Open peer review and authors' responses

Measuring mitochondrial Ca²⁺ efflux in isolated mitochondria and permeabilized cells

Reviewer 2

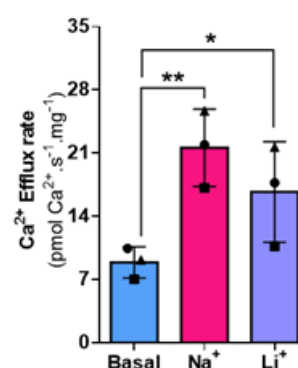
In figure 3, there is no difference in CsA-insensitive basal Ca^{2+} efflux with different concentrations of Ca^{2+} loads. The authors expect differences between $\text{Ca}^{2+}/\text{H}_2^+$ efflux and NCLX in CsA-insensitive Ca^{2+} efflux with different concentrations of Ca^{2+} loads? In other words, it was tested Na^+ and Li^+ -dependent efflux with CsA?

We do not expect changes in the calcium efflux rates mediated by the $\text{Ca}^{2+}/\text{H}^+$ exchanger (CHE) or NCLX in the presence of CsA under the mitochondrial Ca^{2+} load conditions used, as there was no overt uncoupling and the Ca^{2+} load used is far from the maximum retention capacity. These conditions were chosen based on the lack of mtPTP induction after Ca^{2+} uptake. In preliminary experiments using the low Ca^{2+} loads shown in the presence of CsA, sodium-stimulated calcium efflux was unaltered (right).
